Access Compliance Report Public Rights-of-Way (Curb Ramps)

Main Street: OAK_WAY_DR		Cross Street: DRUID_LN		Location:	SW
ADA ID: RPRK211207111631	Ramp Type:Type 1 - Perpendicular Diagonal Initial Pass/Fail: Fail		Overall Compliance: No	Severity Score:	2
Codes/Mitigation Info/Possible Solution			Field Measurements/Component Compliance

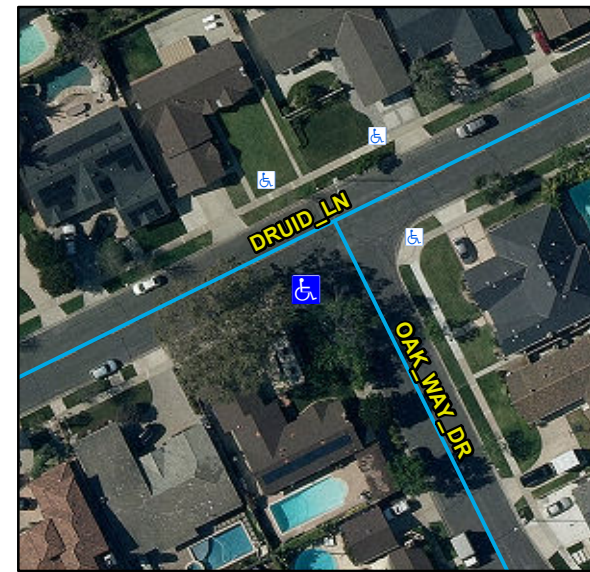
R304.2.2, R204.3, R304.5.3, STD 1115

Remove & Replace Curb Ramp With Two New Directional Ramps or Equivalent.
